ADDENDUM

Addendum Number:	03	Dated:	05/31/2024
Solicitation Number:	MR11493		
Solicitation Title:	Mother Neff State Park Headquarters (HQ) Renovation		
Due Date/Deadline:	June 11, 2024, at 2:00 PM		
Contract Manager:	Misty K. Wyatt, CTCD, CTCM

PURPOSE OF ADDENDUM: **Address Questions and Answers, Revisions to Bid Schedule and Drawings**

SHEET NUMBER
3
M1.0

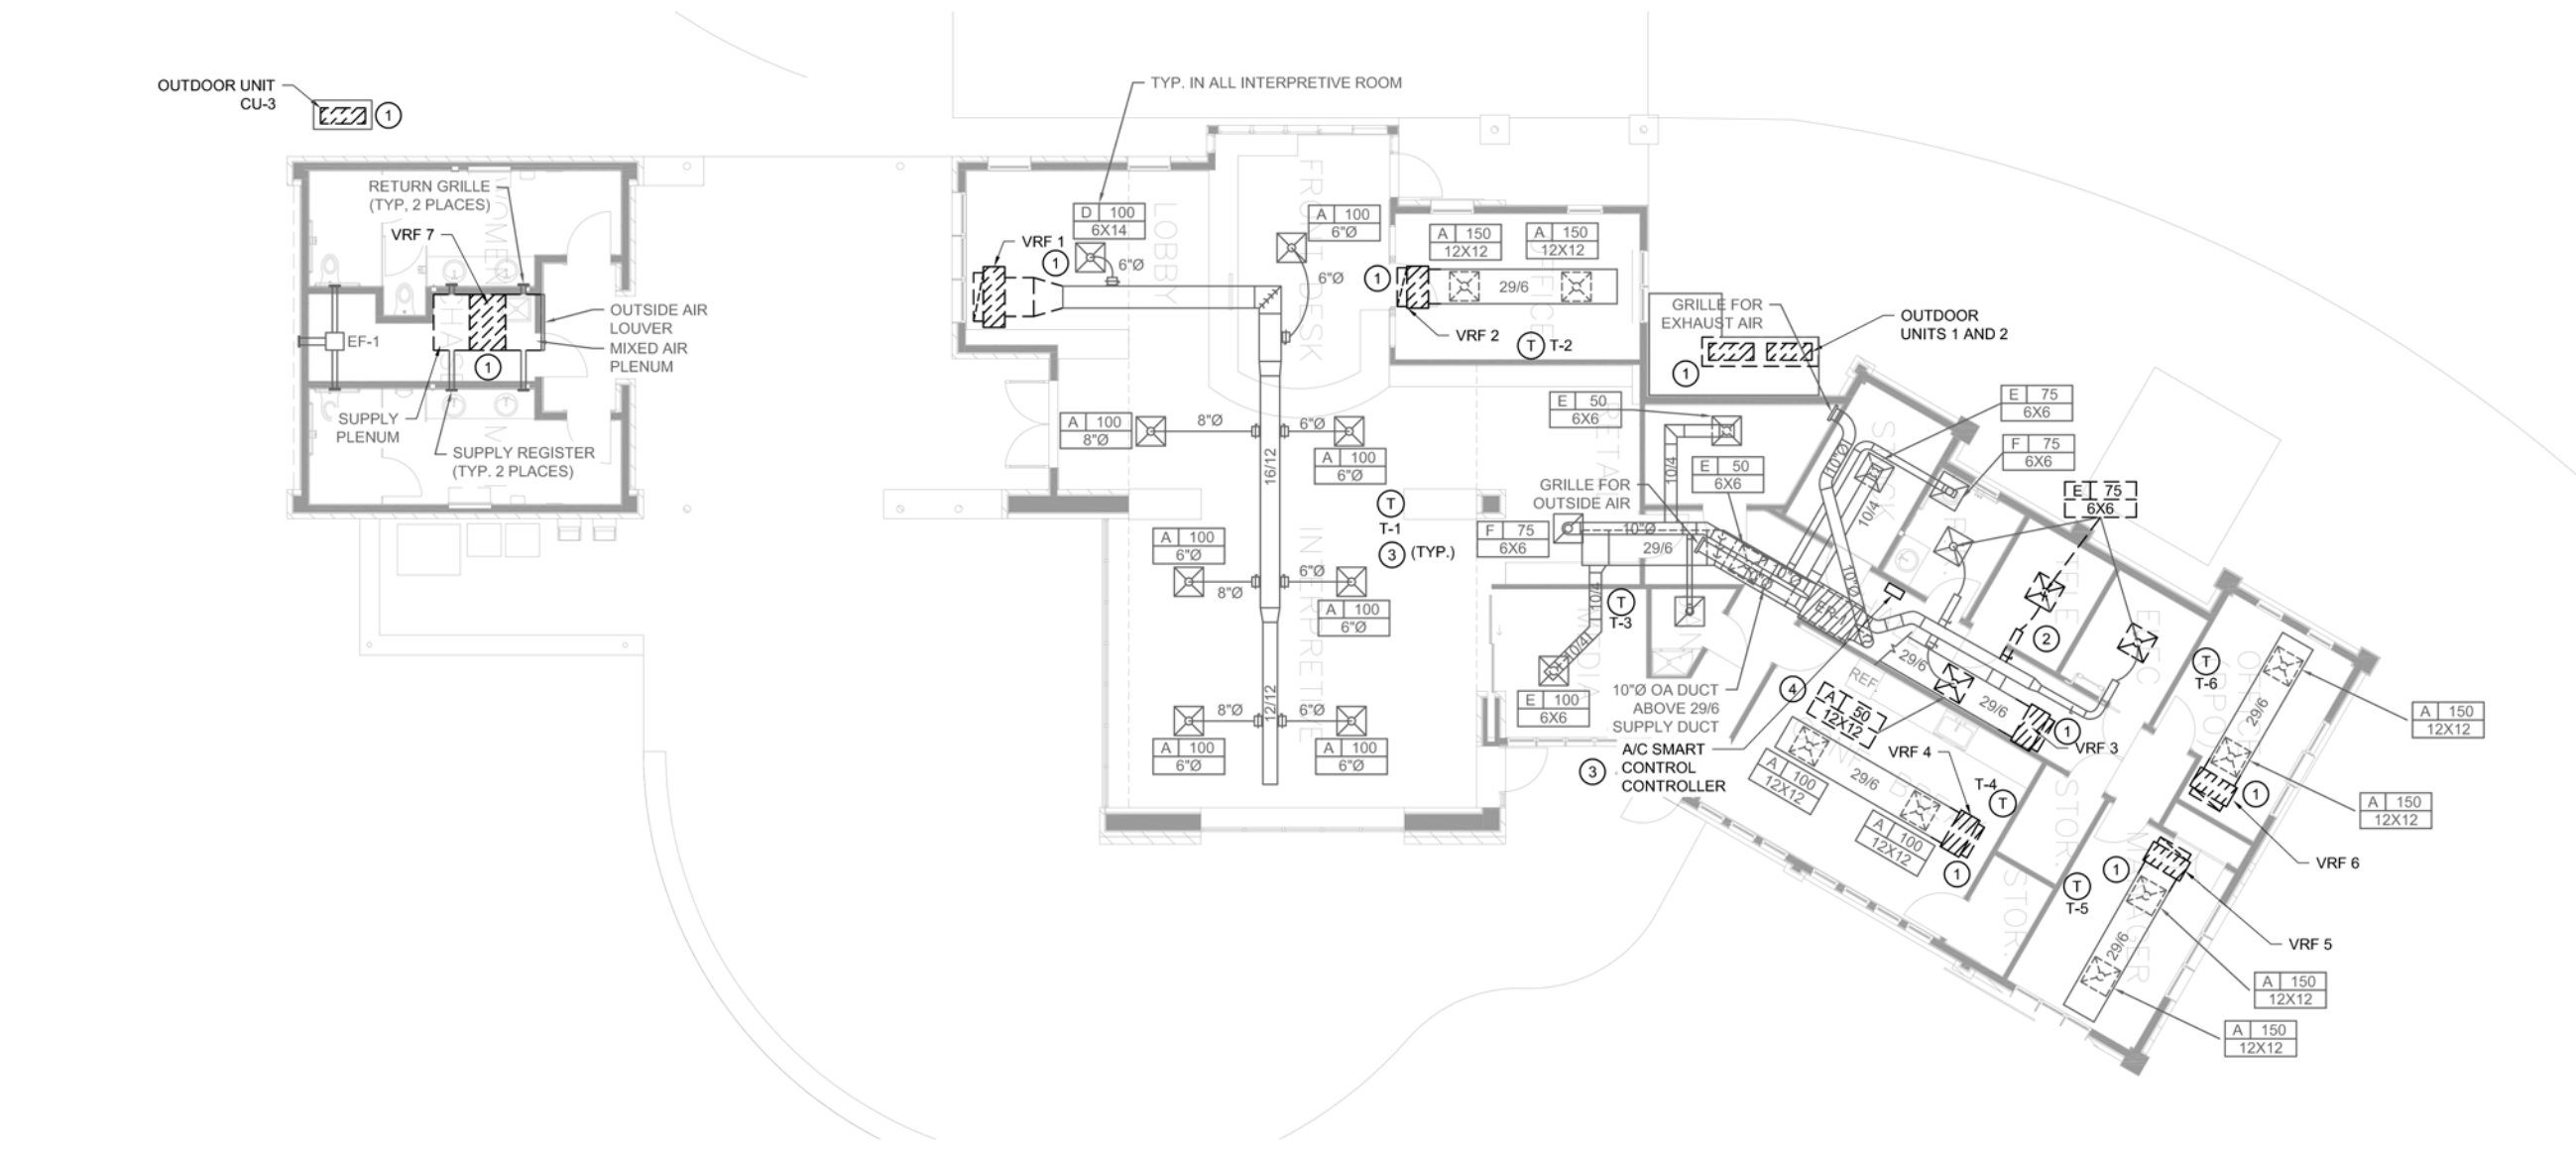
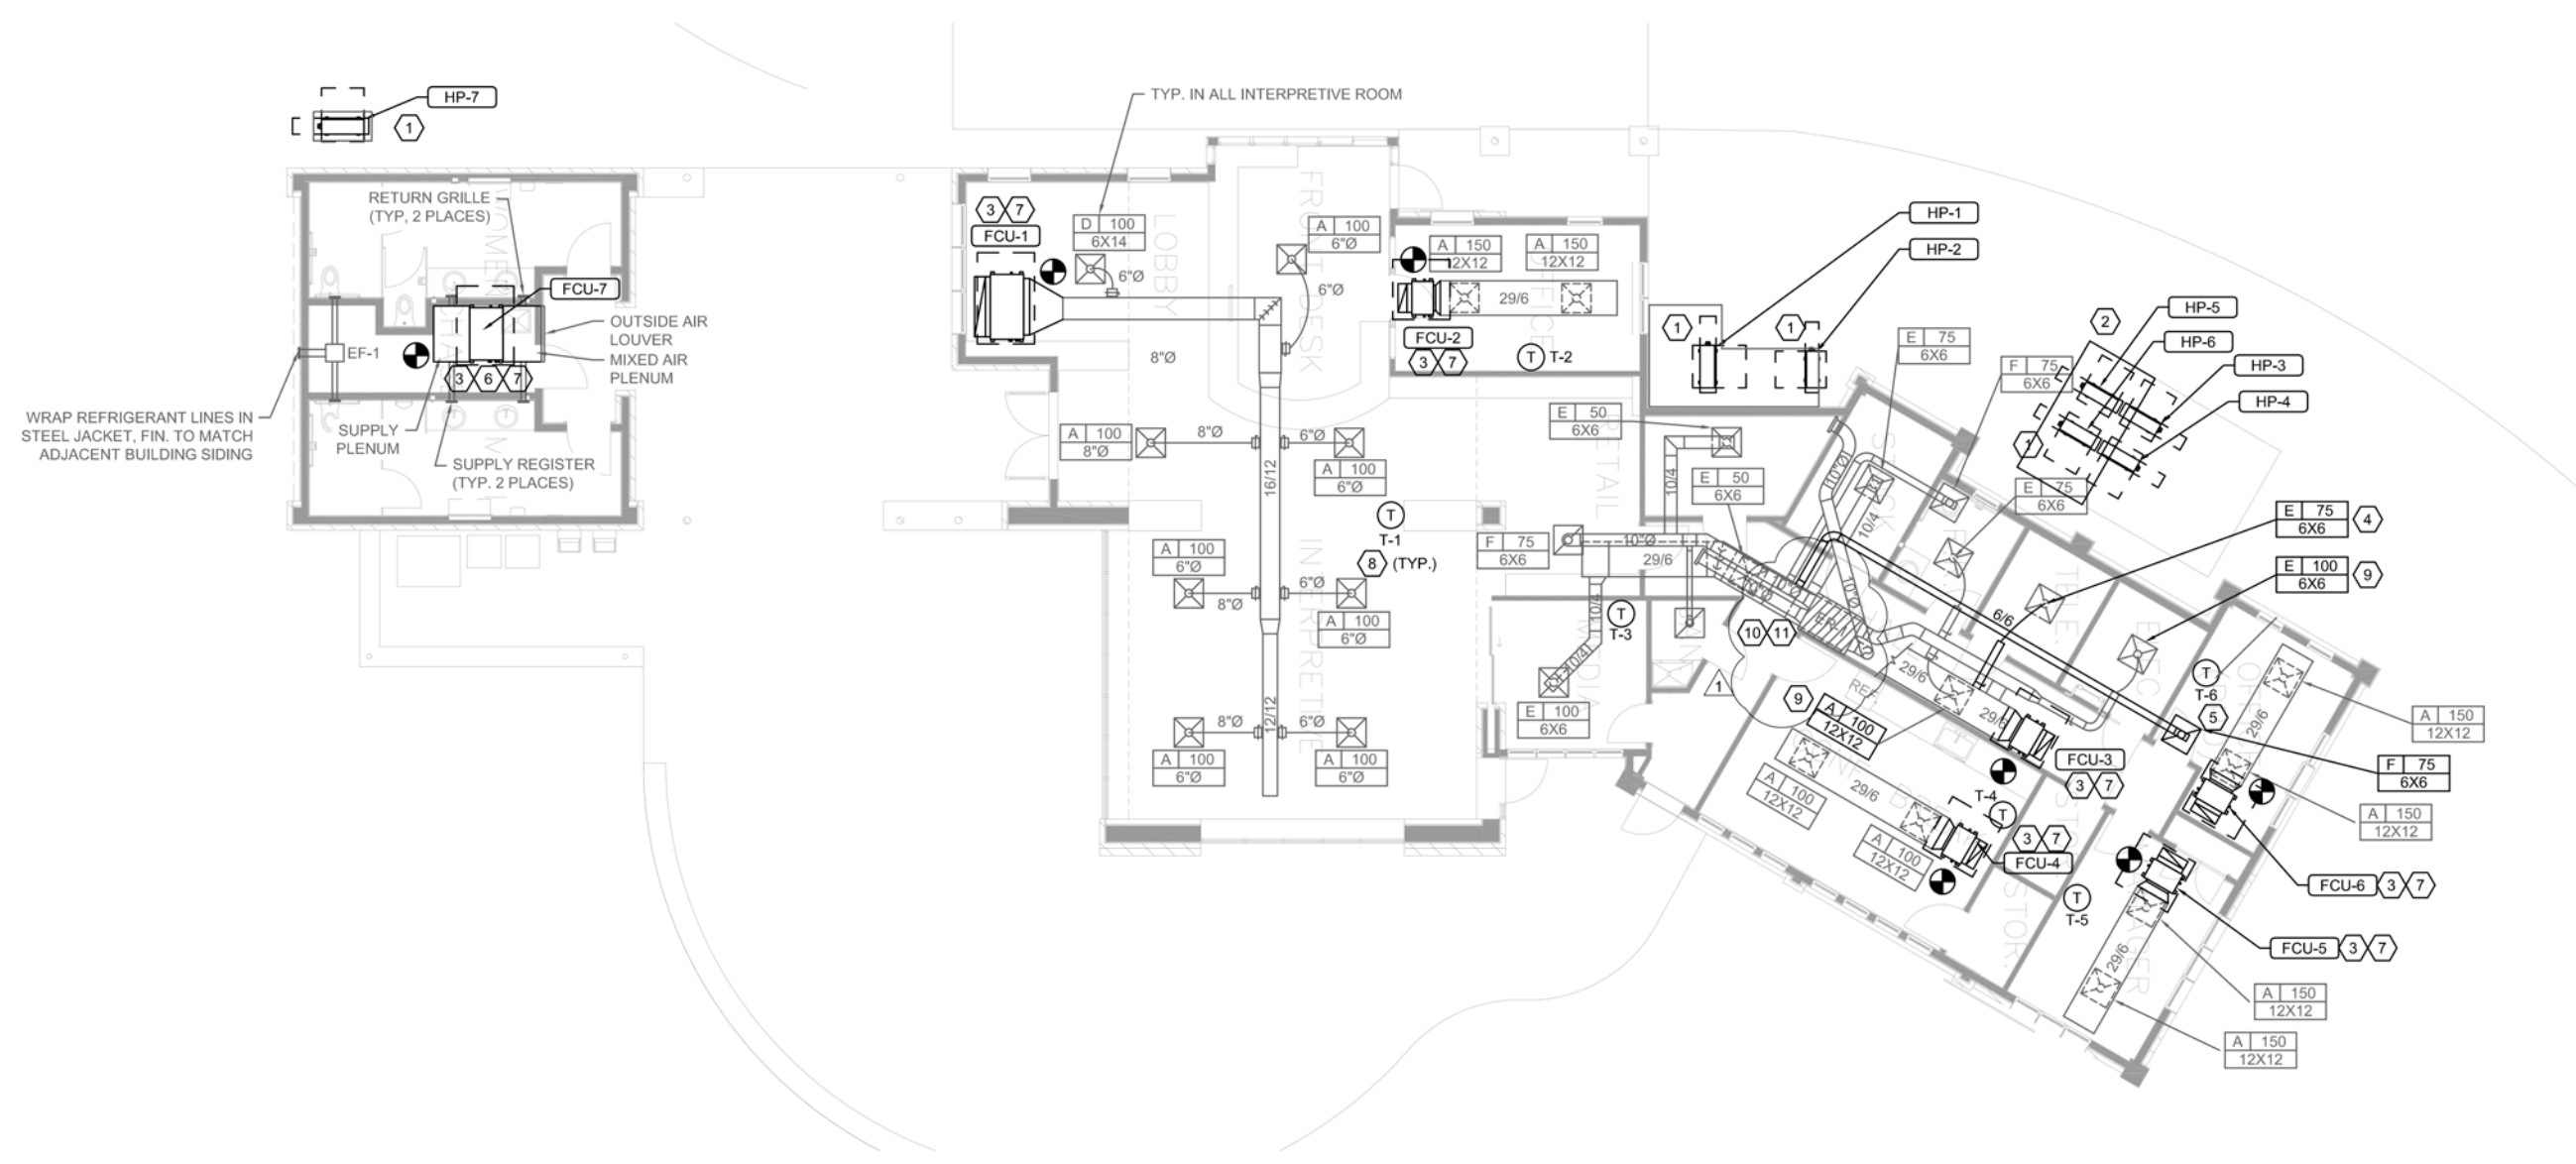
Q11: IS EXSISTING COPPER TO BE REMOVED AND REPLACED?

A11: Existing copper is to be removed and replaced for FCU systems 2 through 8. FCU-1 piping shall be reused, reference Mechanical Drawings. New pipe to be ACR copper pipe per M1.0 & M2.0.

11. (Revision 1) ADD ~45" x 30" ACCESS PANEL IN CORRIDOR CEILING BENEATH ER-1 TO ALLOW FOR FILTER ACCESS. COORDINATE EXACT LOCATION WITH OWNER. FIELD VERIFY SIZE BEFORE ORDER. ACCESS PANEL FRAME IS TO ATTACH TO BOTTOM OF WOOD TRUSSES, AND IS TO SPAN ACROSS CENTER TRUSS. PROVIDE BLOCKING ALONG SIDES OF ACCESS PANEL BETWEEN TRUSSES FOR ATTACHMENT OF ACCESS PANEL. ACUDOR DW-5040 FLUSH DRYWALL ACCESS DOOR WITH HINGE, OR APPROVED EQUIVALENT. ACCESS PANEL TO MATCH ADJACENT CEILING COLOR.
